2 October 2020
Our Ref: 20618A.25PS_RTS letter

RE: SSD-9483 UPGRADES TO CHATSWOOD PUBLIC SCHOOL AND CHATSWOOD HIGH SCHOOL

Figure 4 Amendments to Building G floor plan

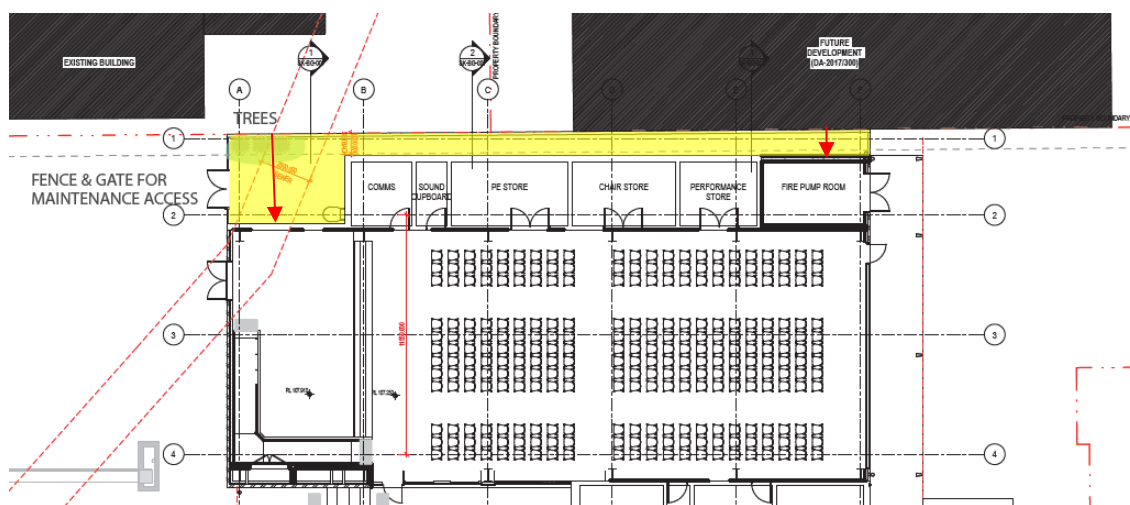
Concern was raised by DPIE in regard to the proposed 0m side setback to the northern boundary, where it adjoins the residential property at 1 James Street particularly in relation to overbearing built form with poor outlook from within the private open space of that property.

In response to DPIE's comments, the design of Building G has been amended as follows:

- Increase setback at the north-west corner of Building G to James Street neighbour;
- Provide overall boundary setback of 1m to the northern boundary;
- Relocated and consolidated bathrooms in the southern part of the plan; and
- Fence and gate added for maintenance.

These changes are shown in yellow in **Figure 4** below and are reflected in the updated Architectural Plans at **Attachment 8** and supported by a Stormwater Engineering Statement at **Attachment 10**.

Table 1 – Summary of Design Review Options

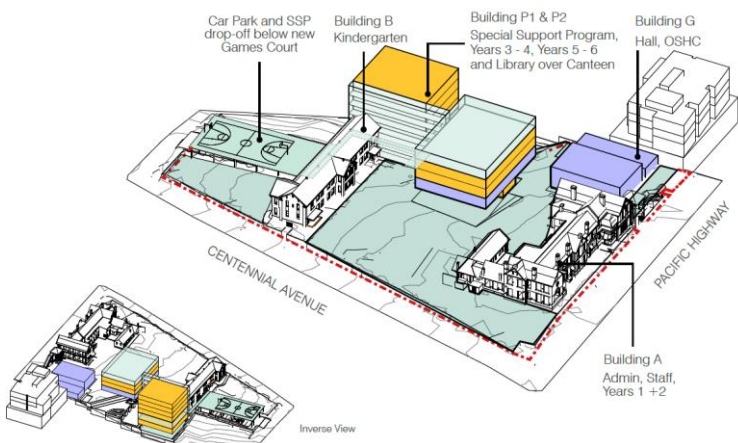
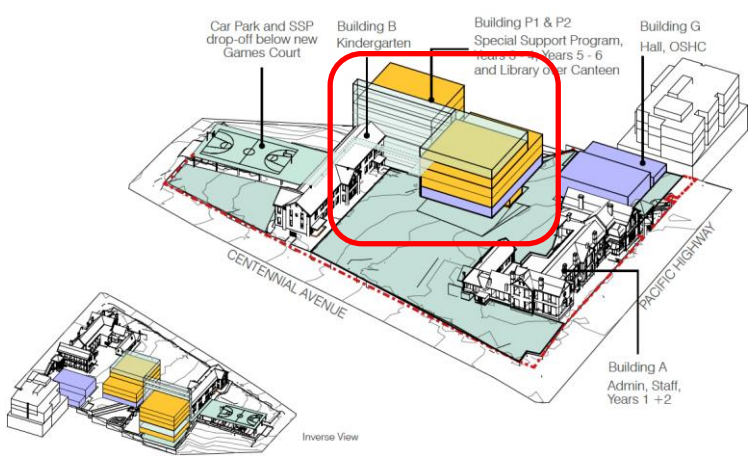
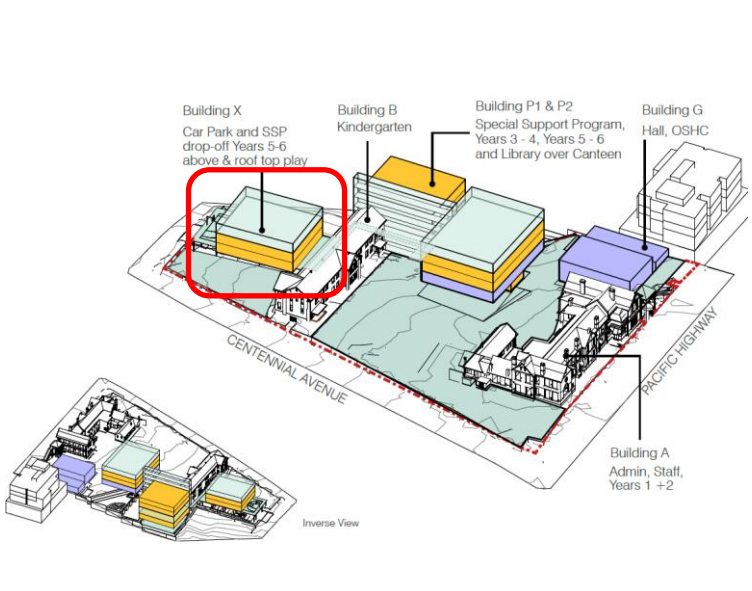
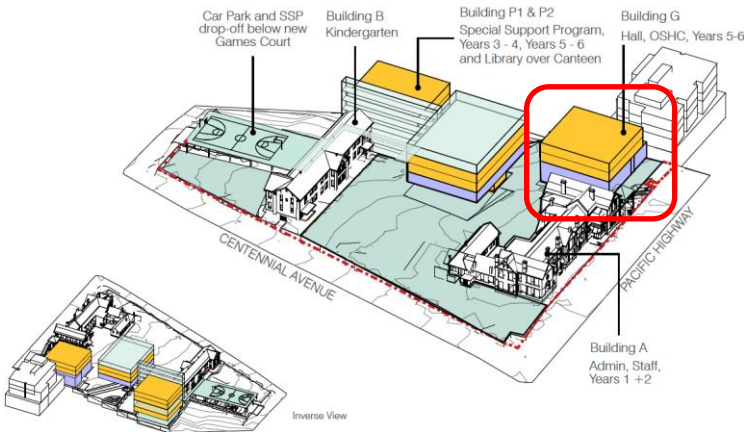
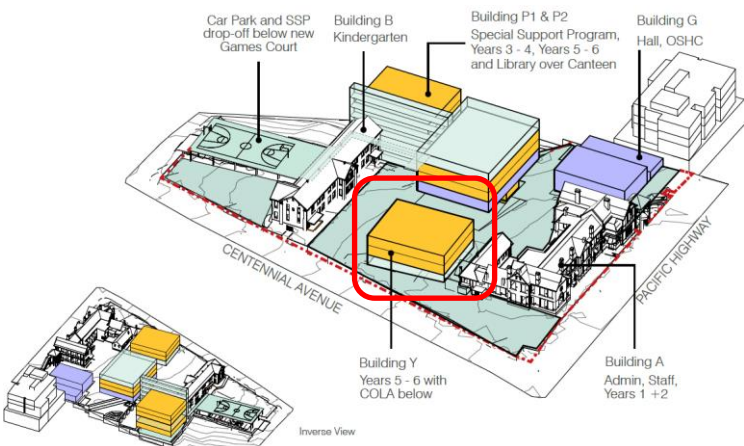
The project team has reviewed the scheme proposed under the SSDA and explored options to adjust the design to distribute height to the centre of the site (i.e. on top of Building P2), or what options are available to relocate the two (2) floors of the building elsewhere on the site.

The primary driver for this was feedback received indicating that the top two floors may be contributing to an appearance of excessive bulk and scale that could be avoided if relocated elsewhere.

Option	Design Review Concept (Change in Red)	Comments
Current		<p>Preferred: Current scheme maximises play space, connects to outdoor spaces from learning neighbourhoods, retains visual connection between Building A and B, maintains streetscape character and is within project program, budget and staging requirements.</p> <p>The built form results in bulk and scale impacts on neighbouring properties at 1 and 3 Jenkins Street.</p>
1		<p>Option 1 disconnects access to roof top play space on P2, reduces the overall play space by removing roof top play space. The relocation of building height to P2 will increase height, bulk and scale impacts on residents at 1 James Street. Moderate level heritage visual impacts on Building A by increasing height adjacent to Building A. Additional costs, significant additional delay, requirement for additional lift to P2 and additional bridge connection for equitable access to roof top.</p>

2A		<p>Option 2A disconnects half of a school stage group from their peers, reduces games courts resulting in less outdoor play space. Students and staff at the new building have to travel further to connect with other classrooms, play areas and staff facilities. The addition of height adjacent to Jenkins Street frontage is not in keeping with the streetscape. The additional built form will exacerbate DPIE's issue about the 'boxed in' feeling for residents. Potential heritage impacts on heritage item across Jenkins Street. Additional costs, significant additional delay, significant impacts on staging of works and construction of car park requires additional core and lifts which affect floor plan efficiency.</p>

Option	Design Review Concept (Change in Red)	Comments
2B		<p>Option 2B disconnects access of roof top play areas, disconnects half a stage group from their peers and teachers from colleagues. Additional storeys atop Building G will diminish the landmark qualities of Building A's streetscape presence. Additional levels will read as secondary to Building A. Potential additional privacy and amenity issues for approved residential building to the north would arise from the western portion of the new building. Cumulative impacts for residents at 1 James Street will be excessive. Additional costs, significant additional delay, and new building would require additional core and lifts that affect planning and efficiency.</p>
2C		<p>Option 2C would disconnect students from their peers, reduce the availability of open outdoor play space, increase the building footprint creating a crowded site, increase supervision burden for all play areas, disconnect early stage and Stage 1 students, and reduce legibility of the site for students. The new building would result in a loss of visual connection between Building A and B, CPTED issues arising from reduced supervision. Potential additional heritage impacts of new built form. Additional costs, significant additional delays, location is highly challenging to build and would affect construction staging and major disruption to ongoing operation of school during build phase.</p>

The outcome of the design options review process was that all options which reduced the height of Building P1 introduced additional negative interface, heritage, educational and program impacts.

Figure 6 Interface section of Building P1 and neighbouring property at 1 Jenkins Street

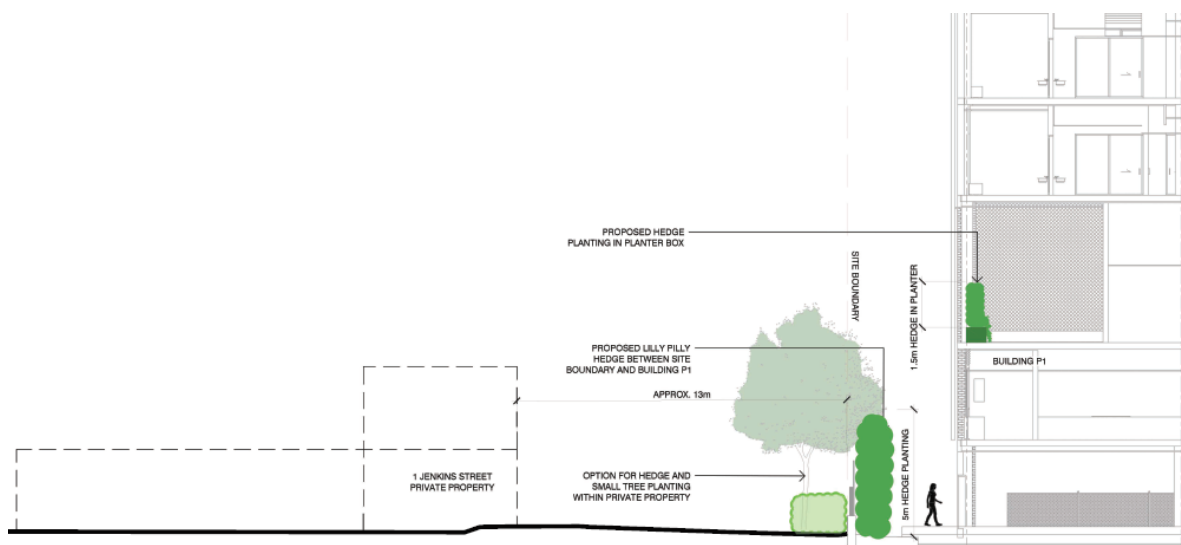
Public submissions raised concern about the height, bulk and scale of building P1, and DPIE raised a range of specific concerns including:

- Amenity impacts of the building on the low scale dwellings at No. 1 and No. 3 Jenkins Street and 2 James Street; and
- Excessive height for this part of the site given wall height, setbacks, shared boundaries, topography of the site and topography of adjoining sites.

Landscaping provided within the COLA and at ground floor will provide additional buffering of view lines and reduce perceived bulk and scale from the built form (**Attachment 12**), including hedge planters at the COLA and additional hedge planting proposed on the lower ground floor level (**Figure 6**).
